Title: Power_Sheet.SchDoc		
File: Telephone Circuit V1.0.PrjPcb		
Date: 26/12/2024	Page	Num: 1
Drawn By: Huzaifa Ali	Page	Total: 5

Title: Connector_Sheet.SchDoc	
File: Telephone Circuit V1.0.PrjPcb	
Date: 26/12/2024	Page Num: 4
Drawn By: Huzaifa Ali	Page Total: 5

Ringer_Coil

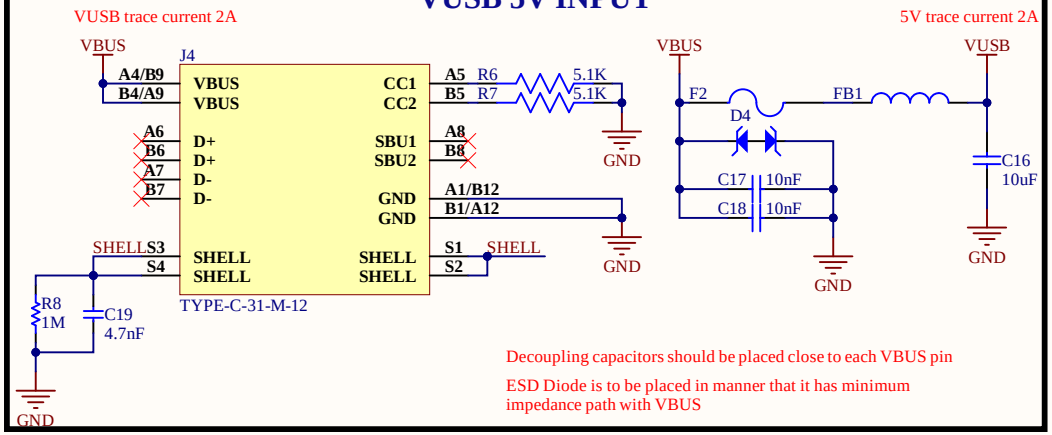
Capacitor need to be updated
is this ok to use terminal block ?
Do we need to add snuber for Coil voltage suppresion
